Response to Reviewers

Manuscript title: Surrogate-conditioned optimizer ranking in block-scale urban energy design: A comparison of policy learning and Pareto search

Manuscript ID: APEN-D-26-08148

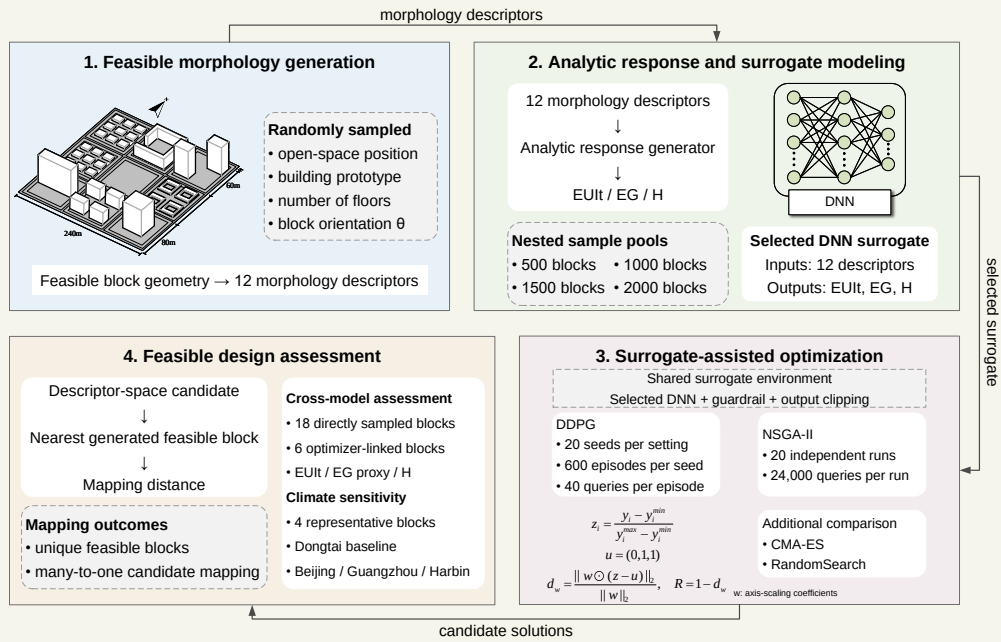
Figure 1: The caption should be improved to explain the content of the figure in more detail.

We thank the reviewer for this helpful suggestion. We agree that the original Fig. 1 caption was too brief for a workflow figure that introduces the full methodology. In the revised manuscript, Fig. 1 is used to orient the reader before the detailed method sections, so the caption now explains the main computational stages rather than only naming the figure.

We revised both the paragraph before Fig. 1 and the figure caption. The paragraph now explains that the study distinguishes generated feasible block geometries, morphology descriptors used by the surrogate and optimizers, and locked block cases used in selected physics-based and climate-sensitive calculations. The caption then describes the workflow in order: feasible morphology generation, analytic response and surrogate modelling, surrogate-assisted optimization, and feasible design assessment.

This revision also prevents a possible misunderstanding in the original manuscript. The figure and caption now make clear that the 2000-sample benchmark uses analytic response assignment, whereas EnergyPlus- and Radiance-component calculations are used later for selected locked cases in the cross-model stress test and climate sensitivity analysis.

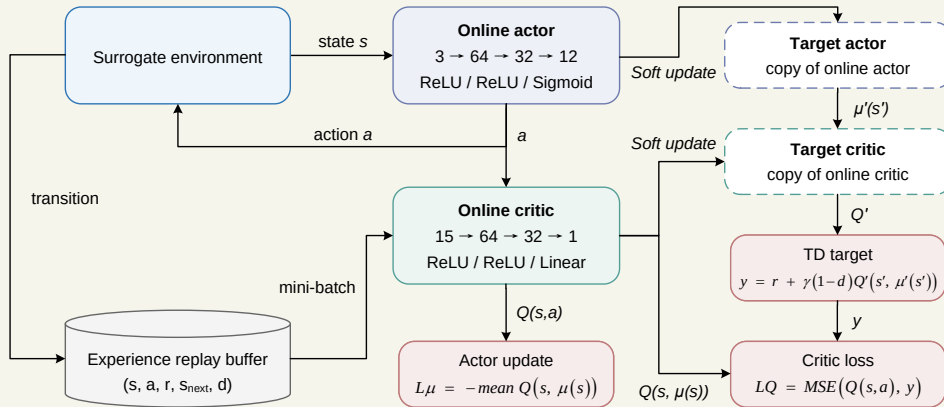
Figure 3: The manuscript does not include the explanation of the Figure 3. Moreover, the authors need to explain the symbols and equations in the Figure 3.

We thank the reviewer for this comment. We agree that the previous manuscript did not explain Fig. 3 sufficiently. The figure contained the actor-critic architecture and update equations, but the surrounding text did not define the state, action, reward, target networks, temporal-difference target, critic loss, and actor update in enough detail.

We revised Section 2.4 and the Fig. 3 caption. The revised text now defines the DDPG state as the normalized three-target vector, the action as the absolute 12-dimensional normalized descriptor query, and the reward as $R = 1 - d_w$. It also explains the online actor, online critic, target actor, target critic, replay buffer, TD target, critic loss, actor update, and soft target-network update shown in Fig. 3.

We also added the reward equations directly in the manuscript. The equations define the normalized target coordinate z_i , the ideal vector $\mathbf{u} = [0, 1, 1]^T$, the weighted normalized distance d_w , and the reward $R = 1 - d_w$. This removes the previous reward-offset wording and makes the symbols in Fig. 3 consistent with the method text.

The revision also connects the equations to the diagram. Readers can now follow one DDPG update from a descriptor action, through guarded surrogate prediction, to the reward and TD target used by the critic. This makes Fig. 3 an explanation of the actual surrogate-query implementation rather than a generic actor-critic schematic.

Revised Fig. 4. Descriptor coverage and cross-validated surrogate predictions.

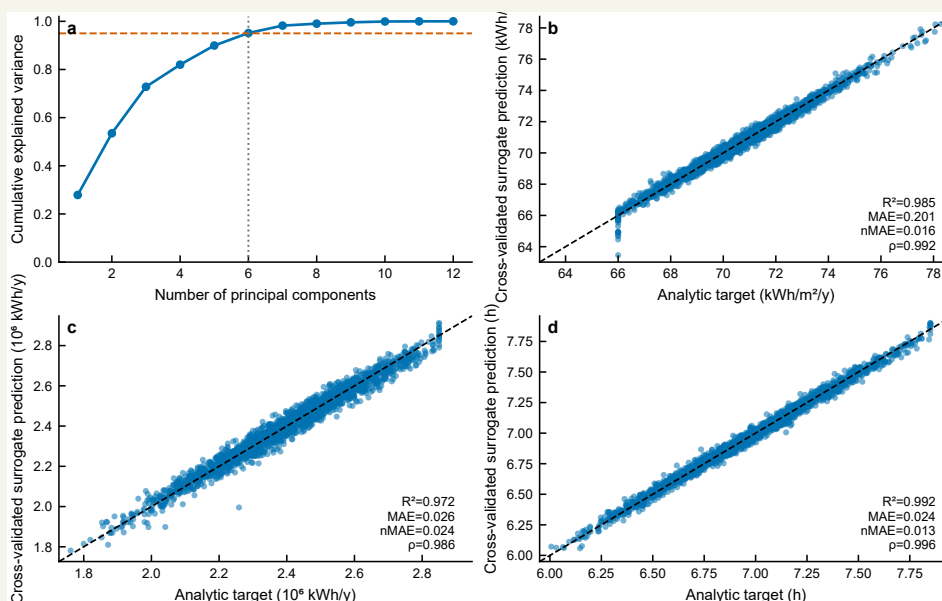
Figure 4: For parity plots, the ticks and limits of the x- and y-axes should be same. All plots should be rescaled. Please specify unit in each axis.

We revised Figs. 4, 5, and 9, Tables 1, 3, and 6, and Supplementary captions and tables to standardize target units, morphology units, one-to-one reference lines, and figure captions. The revised material now gives the reader a more direct account of what was changed and how the revision should be interpreted.

The revised figures and tables label EUIt in $\text{kWh m}^{-2} \text{y}^{-1}$, EG in 10^6 kWh y^{-1} where that scale is used, H in hours, and morphology quantities by their unit or type. This correction changes presentation only; the underlying numerical results are unchanged.

Revised Fig. 6. DDPG training trajectories across the three preference scenarios.

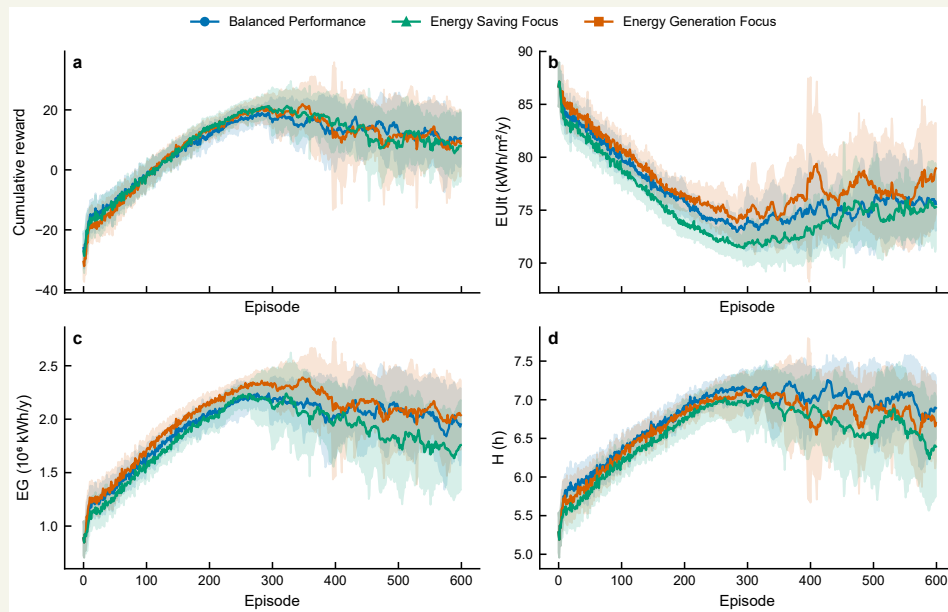
Figure 6: Please explain what the episode means in the plots.

We revised Sections 2.4 and 3.2, Figs. 2 and 6, and Supplementary Section S3.1 to define one episode as 40 surrogate-query steps and align the training-curve captions with that definition. The revised material now gives the reader a more direct account of what was changed and how the revision should be interpreted.

Figure 6 describes how the DDPG agents interact with the guarded surrogate during training. Across the three preference scenarios, rewards increase rapidly during early training and then enter a high-reward region with visible seed-to-seed variability. Because each episode contains a fixed sequence of 40 surrogate queries, the trajectories represent policy-training behaviour on a static response surface. They should therefore be read as search trajectories over descriptor queries, not as the physical evolution of one block design.

Revised Fig. 2. Serialized DDPG surrogate-query workflow. Each episode contains 40 absolute descriptor queries.

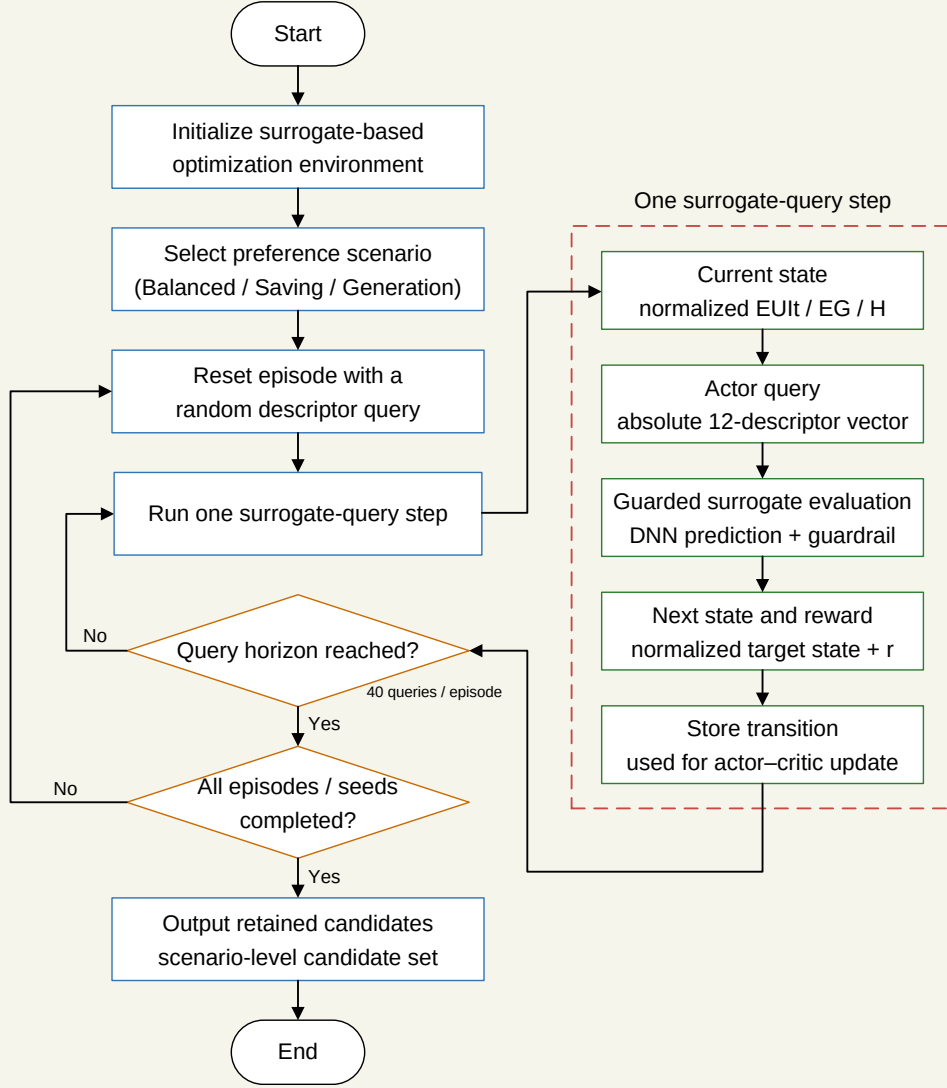
The RL formulation remains questionable because the problem is essentially a static black-box optimization problem rather than a naturally sequential decision-making process. The state transition is determined by the surrogate response to a morphology vector, and the sequential meaning of episodes and steps is unclear.

We revised Sections 1.2, 2.4, and 3.2, Figs. 2, 3, and 6, and Supplementary Section S3.1 to define state, action, episode, reward, actor, critic, replay buffer, and target networks for the static surrogate benchmark. The revised material now gives the reader a more direct account of what was changed and how the revision should be interpreted.

Revised Fig. 1. Workflow linking feasible morphology generation, analytic response assignment, surrogate-assisted optimization, feasible-block projection, and sensitivity analysis.

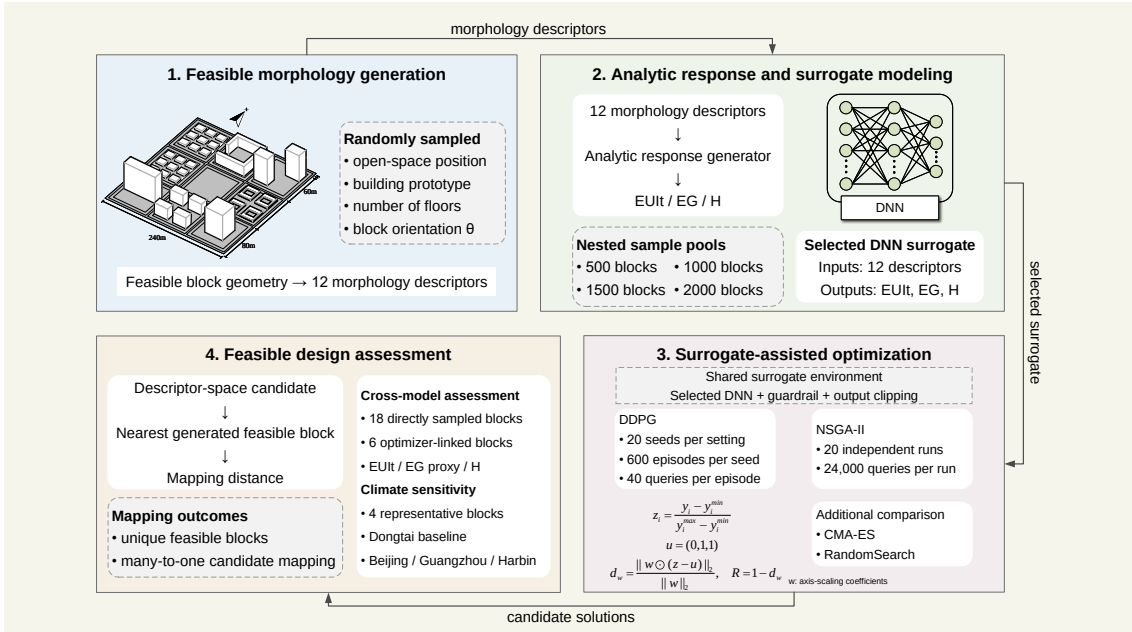
Correct spelling and wording errors in the workflow figures. For example, Fig. 1 still contains visible typos such as "loactions," "Acotr network," and "Critic network," which should be revised to "locations," "Actor network," and "Critic network."

We revised Fig. 1, Fig. 3, and their captions to correct the typo and align figure labels with the revised methodology and DDPG terminology. The revised material now gives the reader a more direct account of what was changed and how the revision should be interpreted.

Fig. 1 now uses consistent workflow-module labels, while Fig. 3 uses standardized labels for actor, critic, replay buffer, target networks, state, action, and reward path. This is a presentation correction and does not change the method or results.

Revised Fig. 7. Descriptor-space DDPG and NSGA-II comparison under fixed-domain utility and equal-size retained outputs.

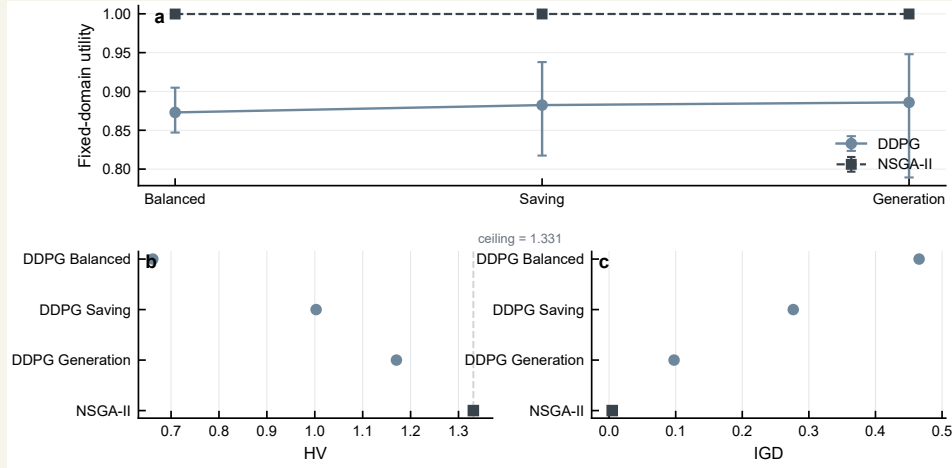
Verify the consistency between Fig. 9(d) and the stated benchmark conclusion. The text states that NSGA-II remains stronger than all DDPG scenarios, but the utility panel should be carefully checked to ensure that the plotted curves, legend, and utility direction support this conclusion.

We revised Sections 3.3 and 3.4, Table 5, Figs. 7 and 8, and Supplementary Sections S3 and S5 to rewrite the comparison around fixed-reference descriptor-space metrics, equal-size diagnostics, and projection. The revised material now gives the reader a more direct account of what was changed and how the revision should be interpreted.

We made three corresponding revisions. First, we rewrote Sections 3.3 and 3.4 to separate scalarized candidate selection, descriptor-space HV and IGD, equal-size diagnostics, and feasible projection. Second, we revised Table 5 and Figs. 7–8 around those criteria. Third, we removed the previous utility-only interpretation from the main claim.

Table 5 summarizes descriptor-space performance under the fixed normalized reference front, while Fig. 7 separates fixed-domain utility from equal-size archive metrics. NSGA-II is close to the HV ceiling under the fixed reference and remains the strongest method in the equal-size HV and IGD comparison. Among the three DDPG settings, the Generation-focused scenario gives the strongest descriptor-space archive metrics, followed by the Energy Saving and Balanced settings.
